# EAGLES NEST SUBDIVISION AMENDMENT 1

PART OF THE WEST HALF OF SECTION 14, TOWNSHIP 6 NORTH, RANGE 2 EAST, S.L.B.&M., U.S. SURVEY  
WEBER COUNTY, UTAH  
MAY, 2016

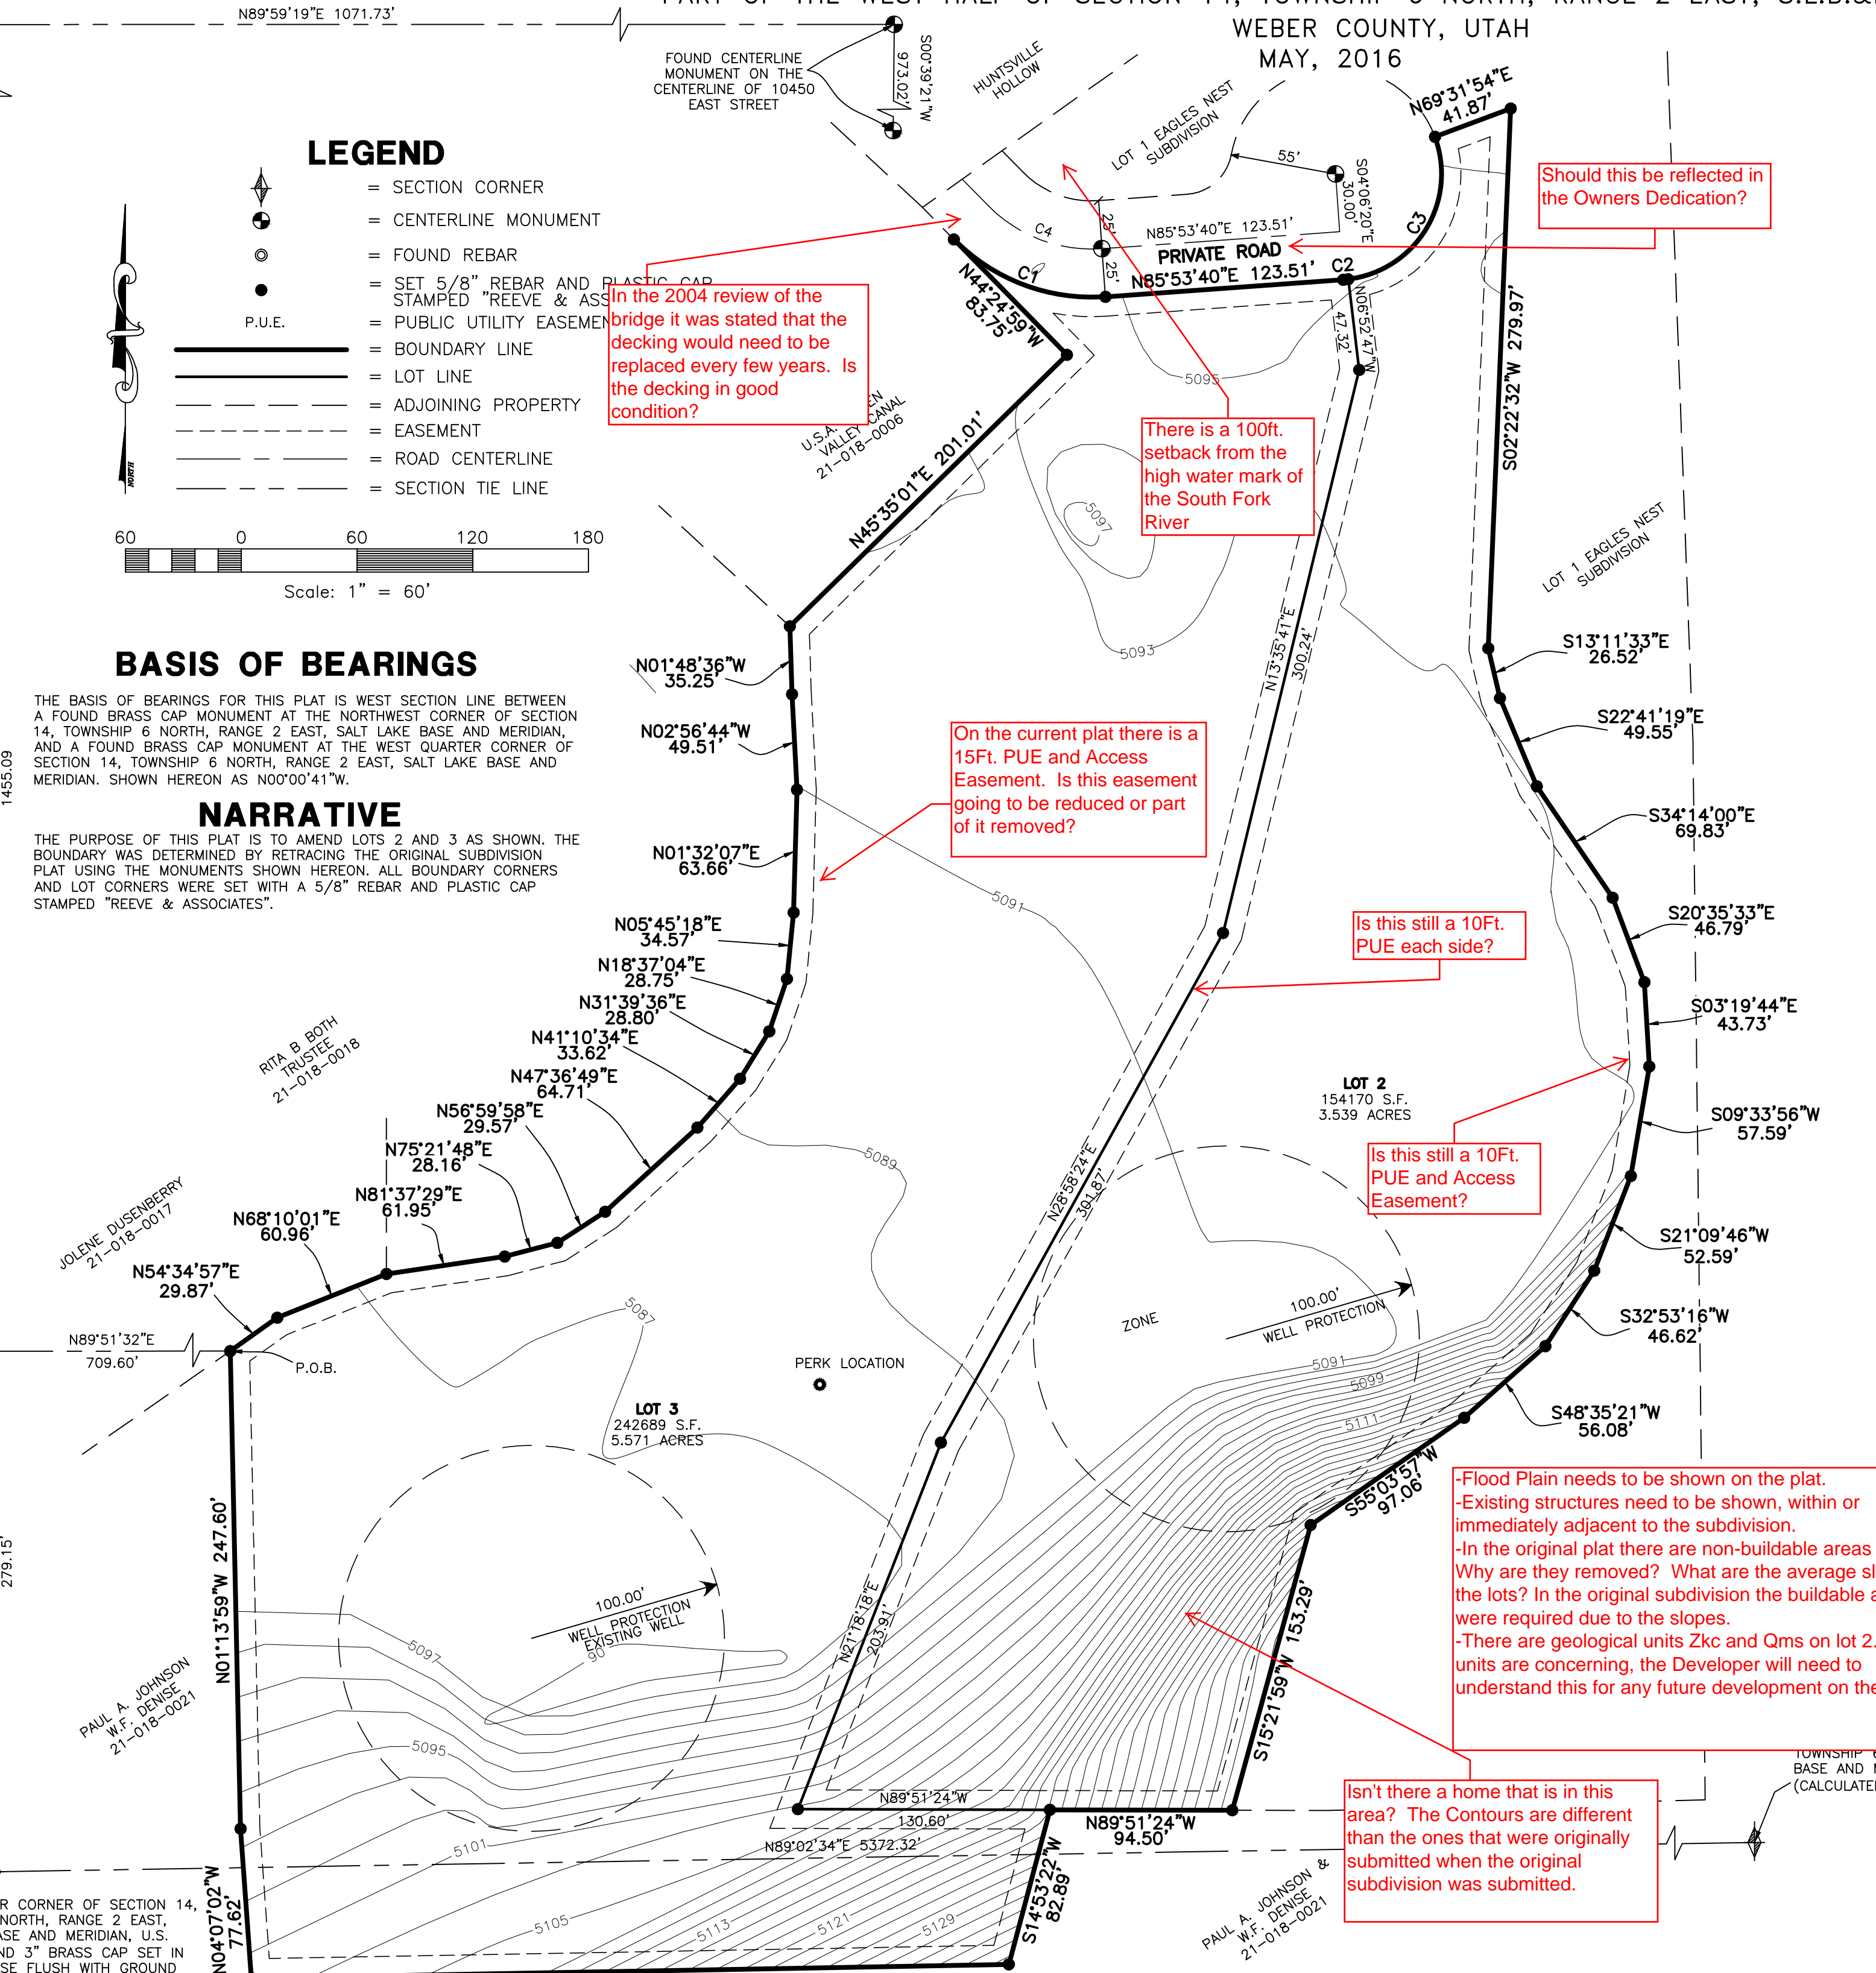
Should this be reflected in the Owners Dedication?

There is a 100ft. setback from the high water mark of the South Fork River

On the current plat there is a 15ft. PUE and Access Easement. Is this easement going to be reduced or part of it removed?

Is this still a 10ft. PUE each side?

Is this still a 10ft. PUE and Access Easement?

-Flood Plain needs to be shown on the plat.  
-Existing structures need to be shown, within or immediately adjacent to the subdivision.  
-In the original plat there are non-buildable areas shown. Why are they removed? What are the average slopes of the lots? In the original subdivision the buildable areas were required due to the slopes.  
-There are geological units Zkc and Qms on lot 2. These units are concerning, the Developer will need to understand this for any future development on the lot.

Isn't there a home that is in this area? The Contours are different than the ones that were originally submitted when the original subdivision was submitted.

Is this the developer?
